WESTSIDE SUBWAY EXTENSION PROJECT

Addendum to the Visual and Aesthetic Impacts Technical Report

August 2011

Figure 5-2. Wilshire/La Brea Station

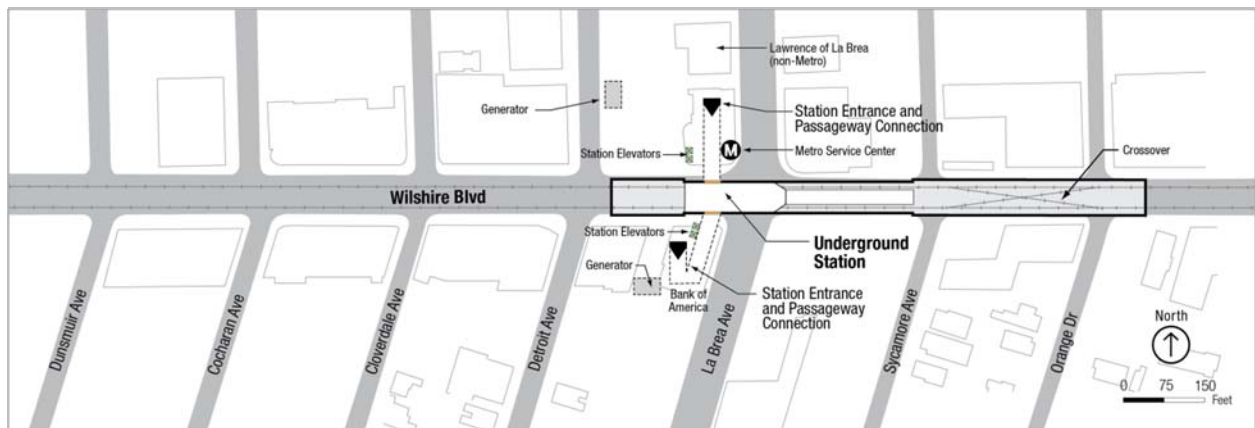
Change The following is a modification of and replaces Section 5.2.3.2

The station entrance will be at the northwest corner of the Wilshire Boulevard and S. La Brea Avenue intersection on Metro-owned property or at the southwest corner as shown in Figure 5-2. Design of the entrance plaza area is expected to complement the Art Deco aesthetic of this commercial and residential neighborhood. The station will also include a one-story structure for the emergency generator along the east side of S. Detroit Street. The generator structure will fit within the visual context of the other station components and nearby three- to six-story buildings.

Figure 5-4. Wilshire/Fairfax Station

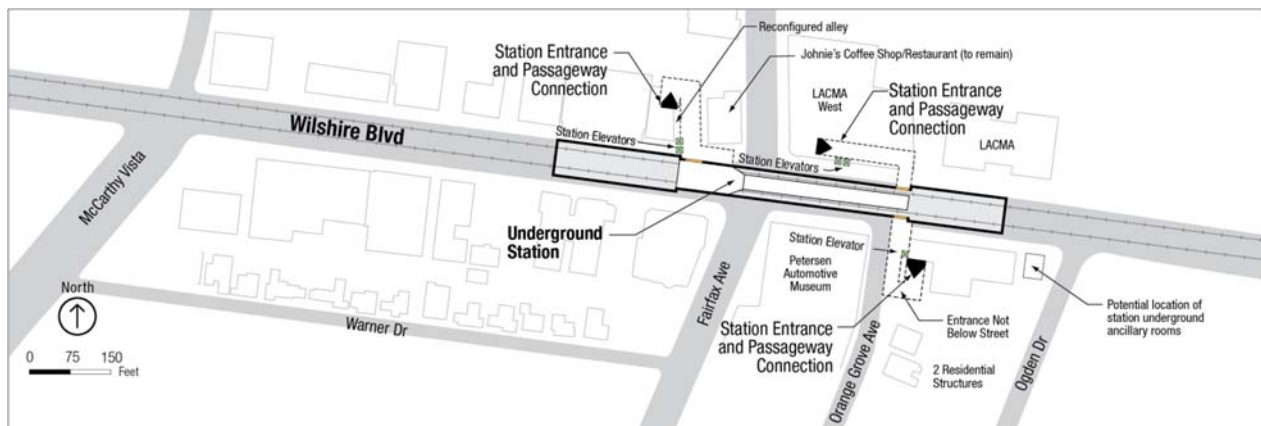
Change The following is a modification of and replaces Section 5.2.3.3

The station entrance will be west of Johnie's Coffee Shop or at alternate entrance options at the northeast corner of Wilshire Boulevard and S. Fairfax Avenue or the southeast corner of Wilshire Boulevard and S. Orange Grove Avenue as shown in Figure 5-4. The aboveground station components are expected to complement the regional visual resources along Wilshire Boulevard, such as the LACMA West building and Petersen Automotive museum buildings, within the Miracle Mile Corridor. Figure 5-5 shows existing and simulated views of the potential entrance west of Johnie's Coffee Shop.

Figure 5-6. Wilshire/La Cienega Station

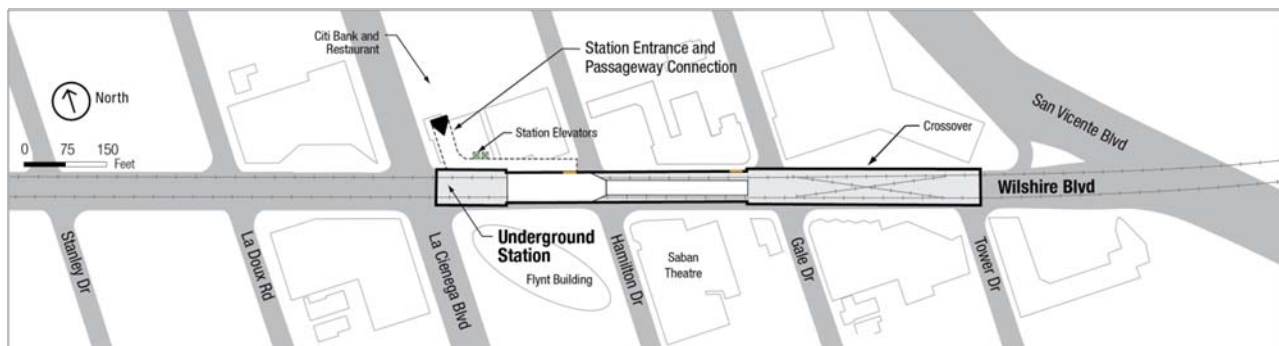
Change The following is a modification of and replaces Section 5.2.3.4

The Wilshire/ La Cienega Station entrance would require the removal of the existing Citi Bank building and a restaurant behind the Citi Bank. The entrance would be an open site that could eventually be part of a joint-development project (Figure 5-6). The station entrance will change the setting and visual character at the Wilshire Boulevard and S. La Cienega Boulevard intersection. However, this change will not be significant and the station entrance may contribute to improving visual quality along this section of the Wilshire Boulevard corridor. The existing view of the Citi Bank site and a simulated view showing the potential plaza and entrance are provided in Figure 5-7. As

Figure 5-7. Wilshire/La Cienega Station (Existing View (top) and Visual Simulation (bottom))

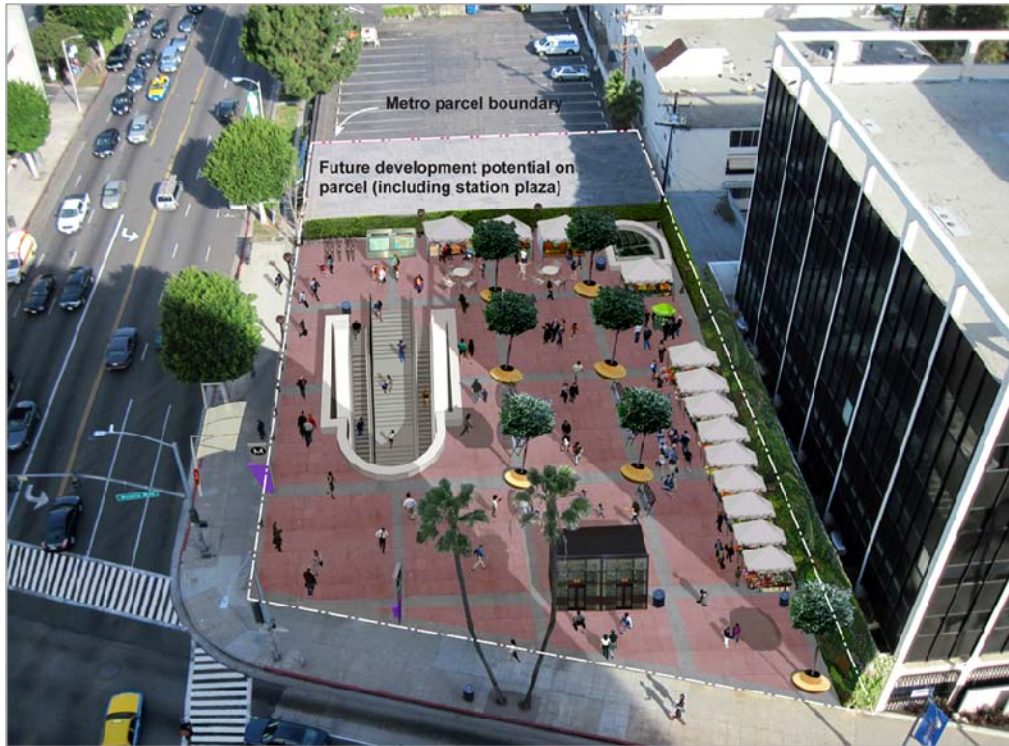
shown by the simulated view, the station entrance would be a prominent feature on the corner. Aboveground station components would include the station entrance structure, signage, defining lighting, benches, landscaping, special paving, art, and bike facilities.

Figure 5-8. Wilshire/Rodeo Station

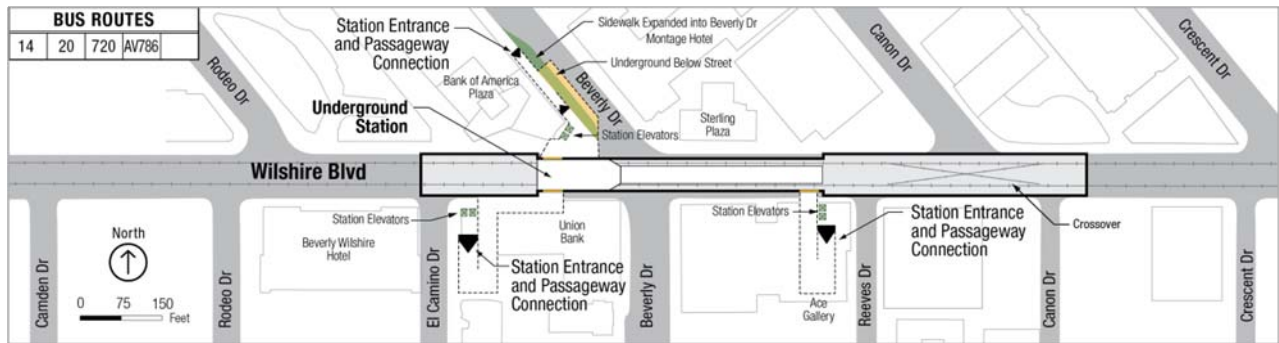
Change The following is a modification of and replaces Section 5.2.3.5

The station entrance will be located on the southwest corner of S. Beverly Drive and Wilshire Boulevard at the current site of the Ace Gallery or at alternate entrance at the Bank of America building at the northwest corner of Wilshire Boulevard and N. Beverly Drive or the Union Bank building on the south side of Wilshire Boulevard (Figure 5-8). Metro will select one of these options.

Figure 5-10. Century City Santa Monica Boulevard Station

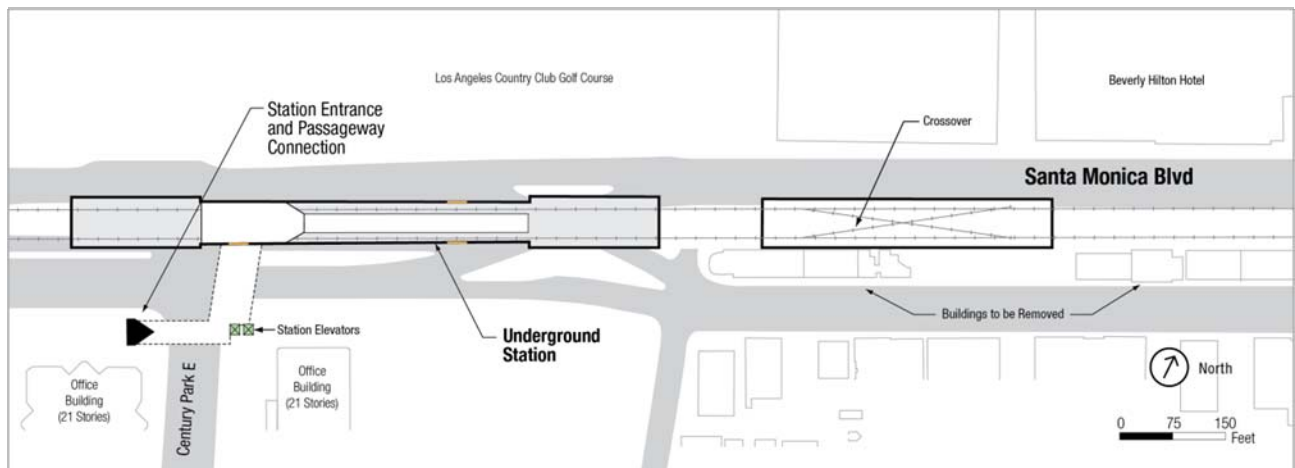
Change The following is a modification of and replaces Section 5.2.3.6

There are two options for the Century City Station, one at Santa Monica Boulevard and the other at Constellation Boulevard. Metro will select one alignment and station location. The station option at Santa Monica Boulevard is shown on Figure 5-10. The Santa Monica Boulevard station entrance is at the southwest corner of Santa Monica Boulevard and Century Park East and would be incorporated into the sidewalk along Santa Monica Boulevard. Consistent with Metro’s canopy design, the entrance would include a plaza with a canopy-covered entrance that would be highly visible and prominent in this area of mid- and high-rise buildings, including from the Los Angeles Country Club golf course on the north side of Santa Monica Boulevard.

Figure 5-11. Century City Constellation Boulevard Station

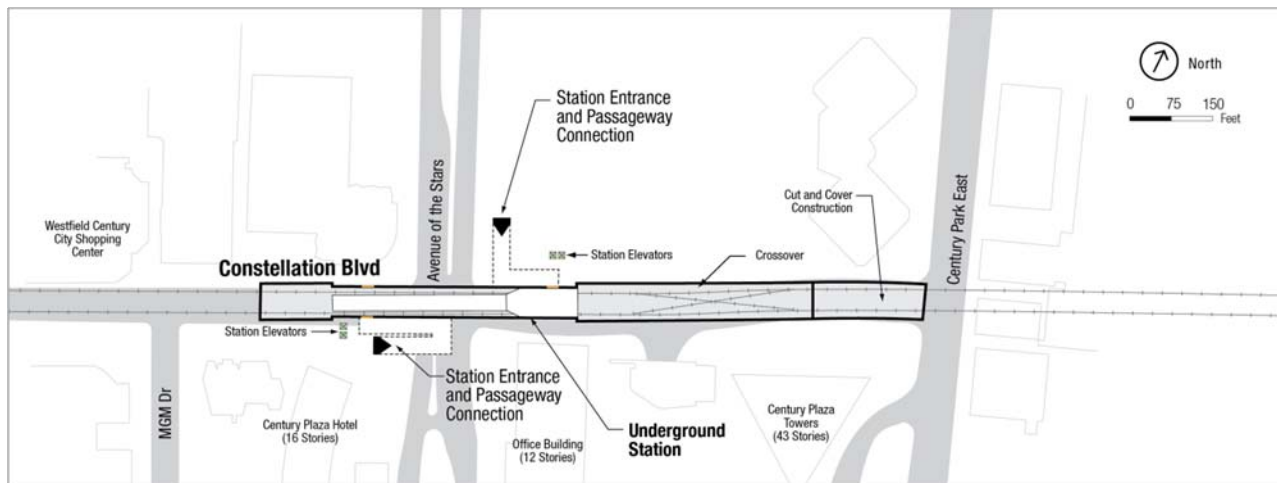
The potential entrances for the Constellation Option are shown on Figure 5-11. The Constellation Boulevard station entrance either would be incorporated into the landscaped area of the Hyatt Regency Hotel plaza or at the northeast corner of Constellation Boulevard and Avenue of the Stars. Visual impacts would be similar to the potential entrance for the Santa Monica Boulevard option, since each would include a plaza with a canopy-covered entrance that would be highly visible from the street and upper floors of surrounding buildings. However, the Constellation Option is located at a busy intersection that is surrounded by office towers, and the canopy in this setting would be less prominent than the canopy for the Santa Monica Boulevard Option. The design for the above-ground

Figure 5-12. Westwood/UCLA Off-Street Station

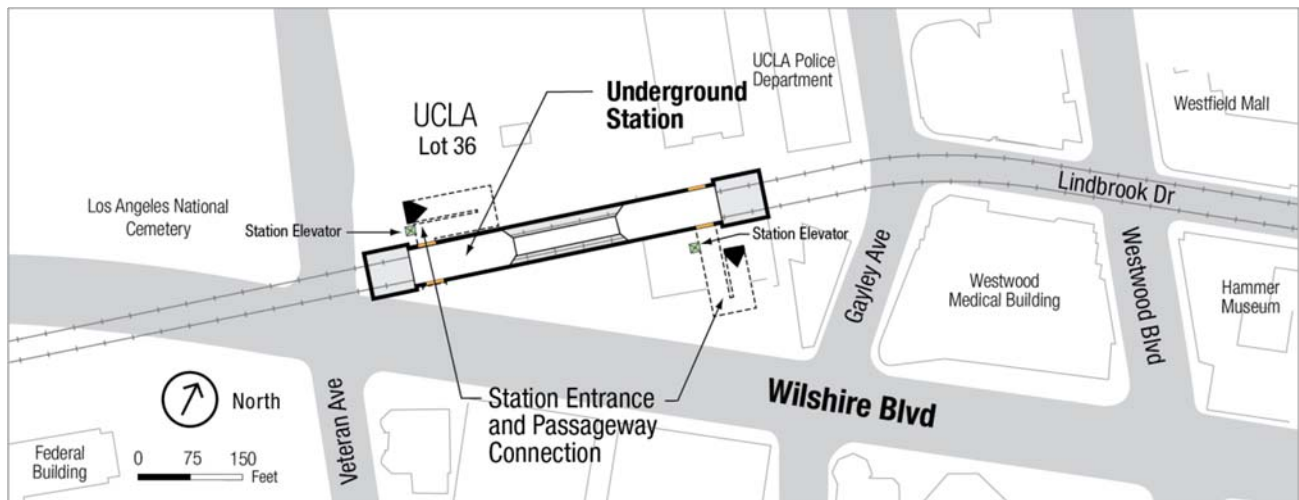
Change The following is a modification of and replaces Section 5.2.3.7

Given the high ridership projections for Westwood/UCLA, two entrances are proposed for each station location. The Off-Street Option would be north of Wilshire Boulevard, between Veteran Avenue and Gayley Avenue (Figure 5-12). The entrance at Wilshire Boulevard and Gayley Avenue for the Off Street Station would be visual prominent. The aboveground station components that would be visible with all of these entrances include signage; defining lighting; streetscape amenities such as benches, landscaping, special paving, and art; and bike facilities such as racks or lockers. The belowground station components visible to viewers would include escalators, elevators, and stairs, as well as the station waiting and boarding areas.

Figure 5-13. Westwood/UCLA On-Street Station

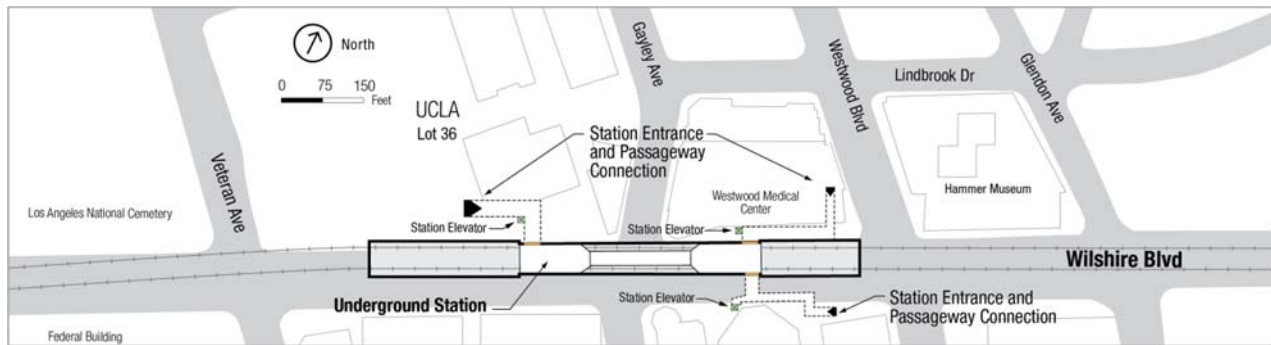
The entrance at the northwest corner of the Wilshire Boulevard and Westwood Boulevard intersection for the On-Street Station (Figure 5-13) would be retrofitted into the existing structure and therefore would not be as prominent as the other entrances being considered. Alternatively, the entrance option on the southwest corner of the Wilshire Boulevard and Westwood Boulevard intersection would be located in the plaza outside of high-rise office buildings. Designs of the aboveground station components for both options would complement the surrounding mid- to high-rise residential towers, hotels, and office buildings. Views in the Westwood area are limited by high-rise buildings. No scenic vistas would be adversely altered by either station option. In addition, none of the potential station entrances are located in Westwood Village, where they could contrast with the village character created by wide sidewalks, street-facing retail shops, and shade trees.

Figure 5-14. Westwood/VA Hospital South Station

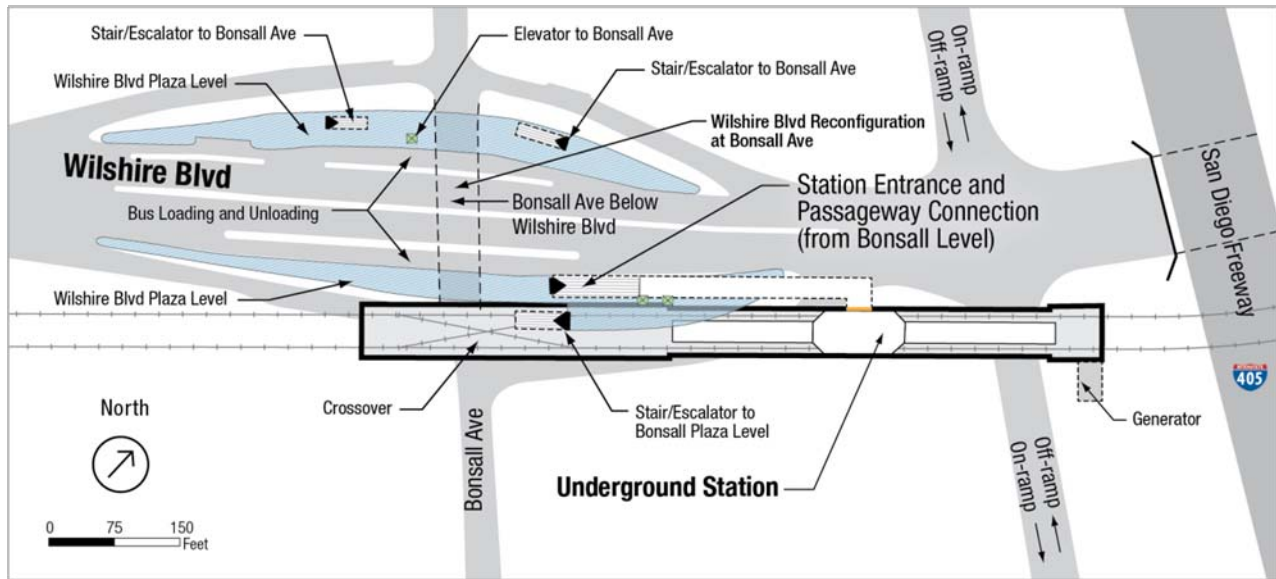
Change The following is a modification of and replaces Section 5.2.4.1

There are two options for the Westwood/VA Hospital Station: one north of Wilshire Boulevard and the other south of Wilshire Boulevard. The entrance for the South Station would be in the parking lot at the southeast corner of Wilshire Boulevard and Bonsall Avenue (Figure 5-14). The South Station would also include a one-story structure for the emergency generator east of the entrance and a three-story parking structure on the site of an existing parking lot east of the VA Hospital. The generator structure would fit within the visual context of the other station components and would not alter any scenic vistas. The parking structure would block some territorial views to the east from the first- through third-story windows of the VA Hospital.

Figure 5-15. Westwood/VA Hospital North Station

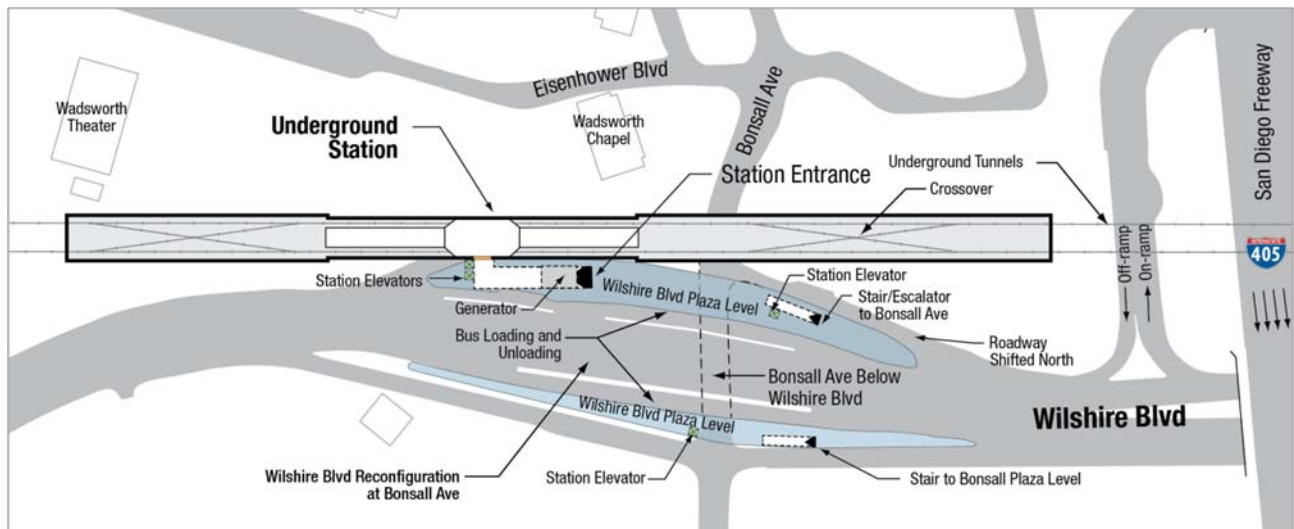
The entrance for the North Station would be along the north side of Wilshire Boulevard just west of Bonsall Avenue (Figure 5-15). The North Station would also include a one-story structure for the emergency generator east of the entrance, near the I-405 ramps. The generator structure would fit within the visual context of the other station components and would not alter any scenic vistas.
